REGULATION 4 OF THE INFRASTRUCTURE PLANNING (CHANGES TO, AND REVOCATION OF, DEVELOPMENT CONSENT ORDERS) REGULATIONS 2011 APPLICATION TO MAKE A NON-MATERIAL CHANGE TO THE OAKLANDS FARM SOLAR PARK ORDER 2025 (SI 2025/739) AS CORRECTED BY THE OAKLANDS FARM SOLAR PARK (CORRECTION) ORDER 2025 (SI 2025/1070)

EN010122 – Oaklands Farm Solar Project Non-Material Change Application.

Interested Party Reference number: 20047649

Amy Wheelton Independent Seales South Derbyshire District and Linton Division
Derbyshire County Councillor

nsip-documents.planninginspectorate.gov.uk/published-documents/EN010122-000819-EN010122 D7 6.1 ES Chp8 Appx 8.1 Flood Risk Assessment and Outline Drainage Strategy Clean.pdf

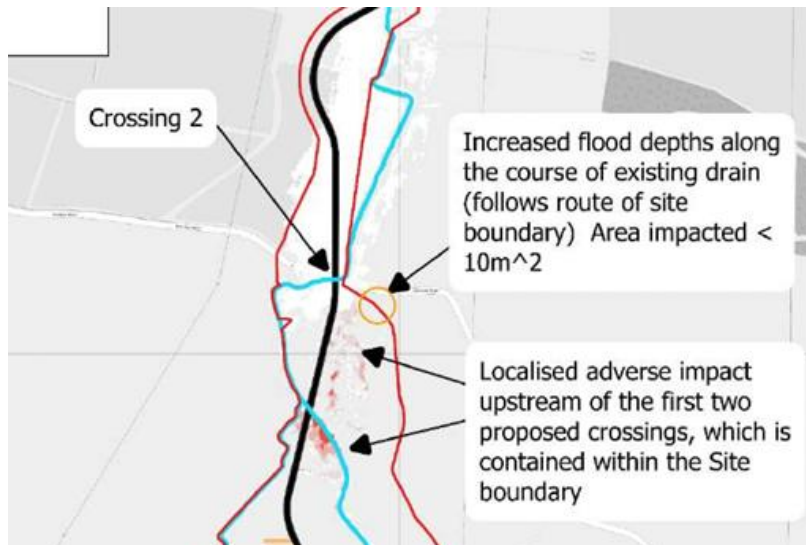
Please note for all these conditions it does not fulfil the requirements of the Development Consent Order (DCO) in that the submitted details do not “include the plans and strategies referred to in the flood risk assessment” as required by Requirement 17 part 2 of the DCO as they are not in accordance with the flood risk assessment which shows clearly land near Rosliston road may flood by up to 20cm. Please refer to FRA document dated Dec 2024.
